RIDGWAY PLANNING COMMISSION

AGENDA

STAFF REPORT

Request: Replat
Legal: Blocks 2 and 8, River Park Ridgway Business Park Planned Unit Development, Filing 1
Address: TBD Cora Street
Parcel #: 430516223067 and 430516202006
Zone: Light Industrial 1 (LI-1)
Applicant: Ridgway Light Industrial
Owners: Ridgway Light Industrial, LLC (Block 8) and Chad Baillie (Block 2)
Initiated By: Shay Coburn, Town Planner and Jen Coates, Town Manager
Date: October 30, 2018

Issue Record:
PROGRESS 10-10-2018

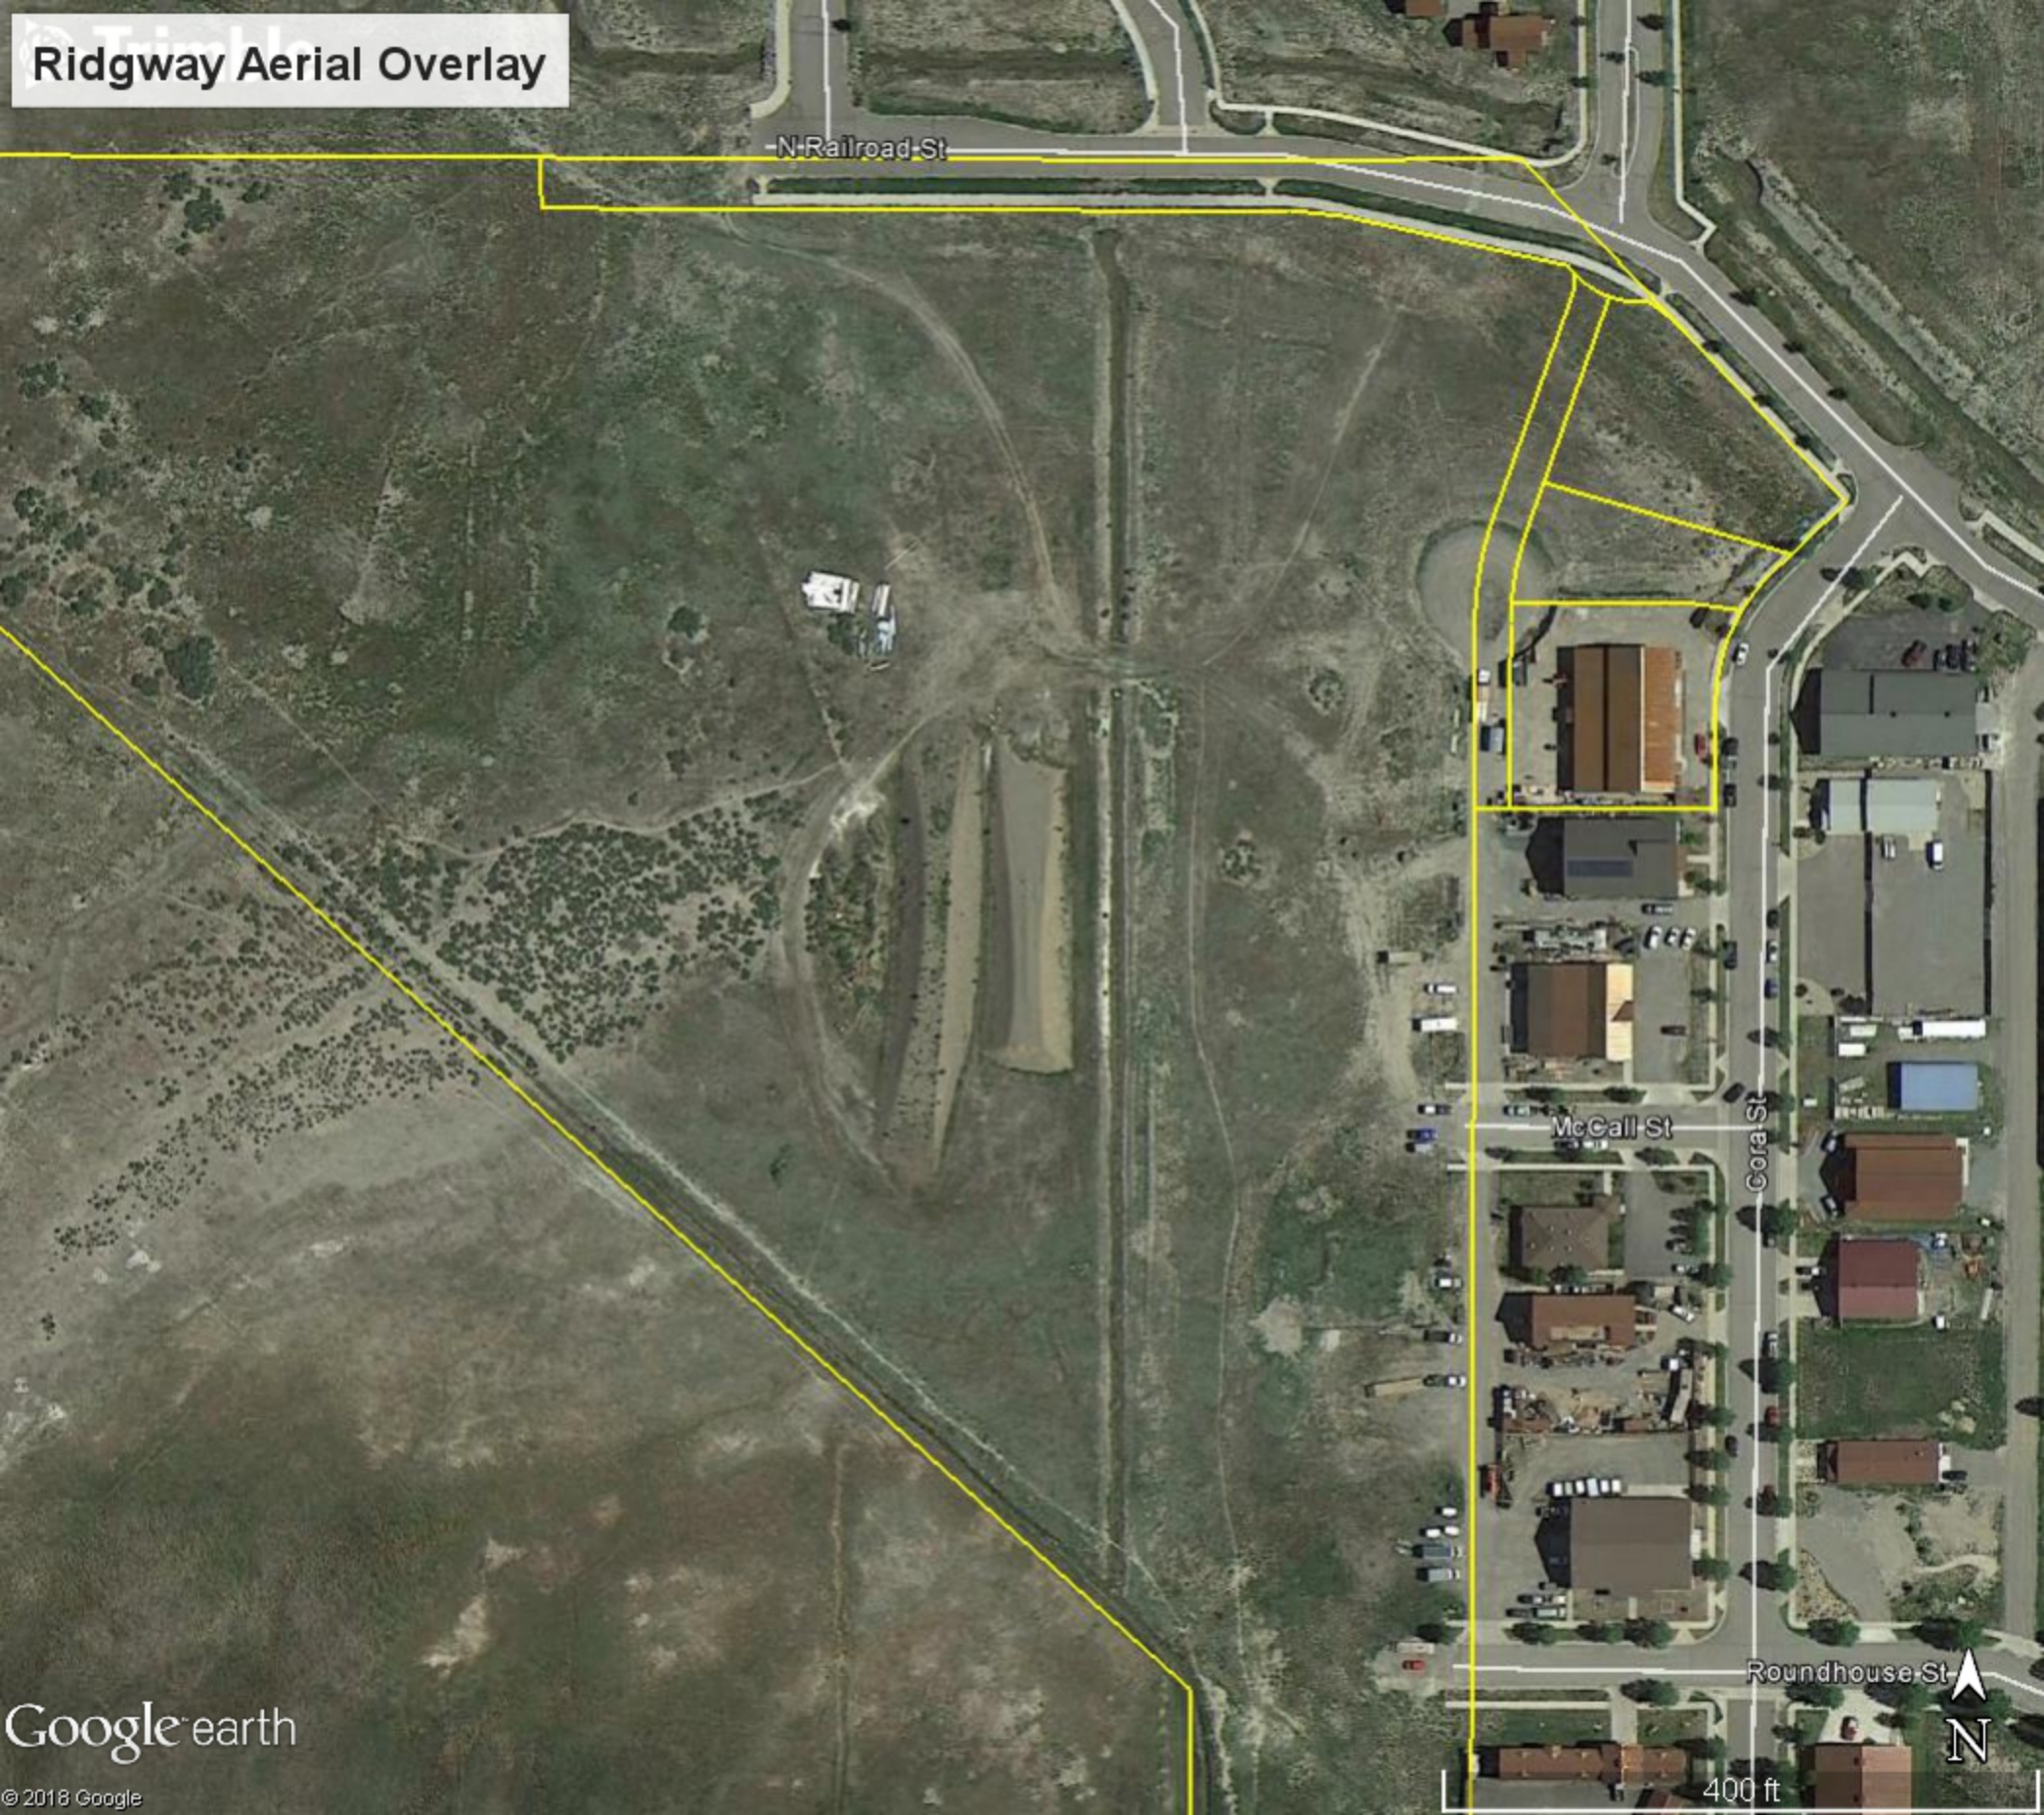
The applicant submitted plans by an engineer for the new alley and intersection. The following comments have been provided by the Town Engineer:

- The plans need to be stamped by an engineer.
- Sewer:
 - The sewer line extension appears to go just barely onto lot 2 within the proposed utility easement. This is fine but if someone wants to put a fence at their property line it may have to be taken down for repairs. It would be preferred if the sewer could move fully into the alley right-of-way.

- The arrow leader for item number 4 on the plans seems like it is pointing to the wrong thing.
 - Where will the sewer service lines be tapped into the main line?

- A few spot elevations are needed on the plan to show how the new alley will interface with the existing pavement on Railroad. The roundabout location is slightly different than what was planned in filing 1 due to the addition of the alley. It will be important to be sure this intersection is designed properly.

- Alley A Profile:
 - Show that the sidewalk, landscape strip and curb/gutter will be removed.
 - Depth of the water line should be about 5'. The drawing is showing it much deeper.

- Construction keynotes:
 - 1: add that sidewalk will be ADA accessible

Current Proposal

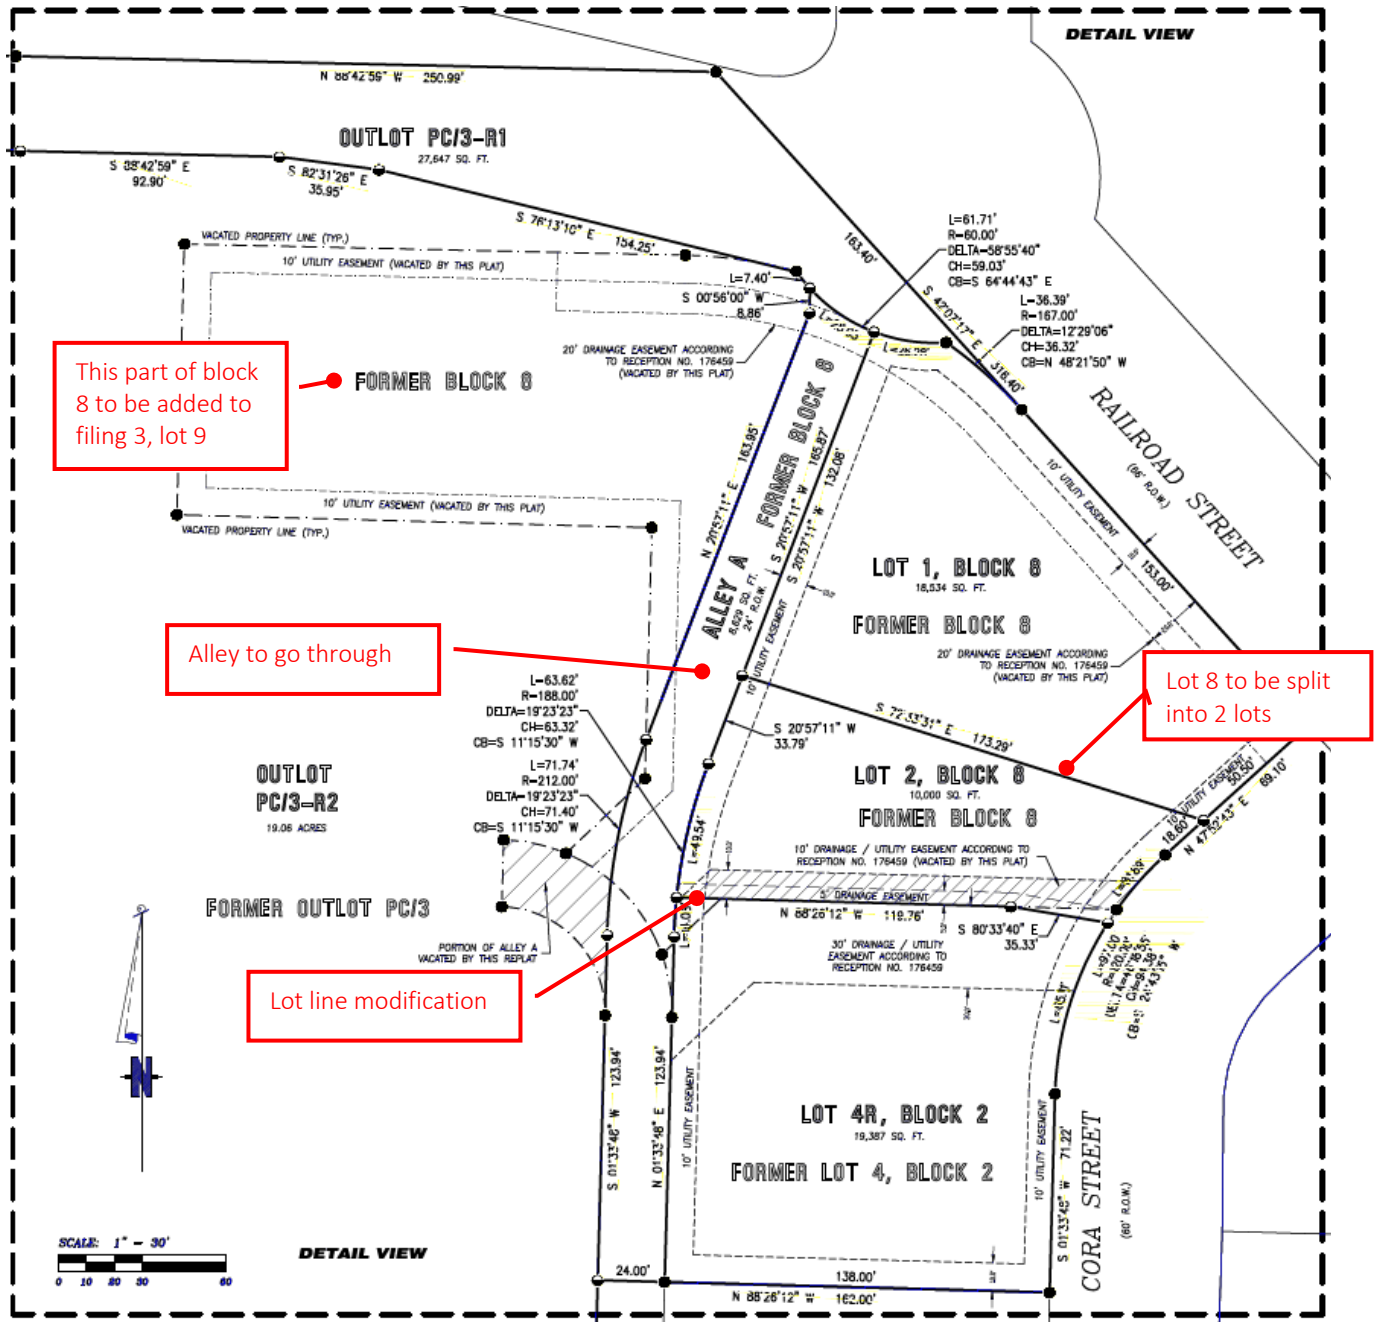
The filing 3 preliminary plat map is shown below. The northern most lot line of block 9 will need to be adjusted for the final plat application to match this proposal including adding the area for the roundabout. This area is circled in red on the map below.

The proposal reviewed by the Planning Commission in August proposed to vacate the 120' diameter "roundabout" at Railroad Street and River Park Drive, just north of Block 8. This is consistent with the currently approved preliminary plat for filing 3. The Planning Commission discussed this roundabout in the August hearing and mentioned that they would like to explore the option to include the roundabout as proposed in filing 1. The Commission asked for information on the intensity of traffic and how it will change with this alley that connects to Railroad Street. For example, how many tractor trailers will now use the alley/RR/RP intersection? What can be done to mitigate traffic?

This new submittal maintains the option to add a roundabout at the intersection with Railroad but no information on traffic except truck turning radius has been submitted. The applicant explained to staff that the traffic counts on the alley are so low that there isn't any useful data. They offered to put a sign at the stop sign (assuming at the north end of the new alley) to show the direction to Highway 62 if that would be helpful. The Planning Commission may want to discuss if building the roundabout will be a requirement of this replat.
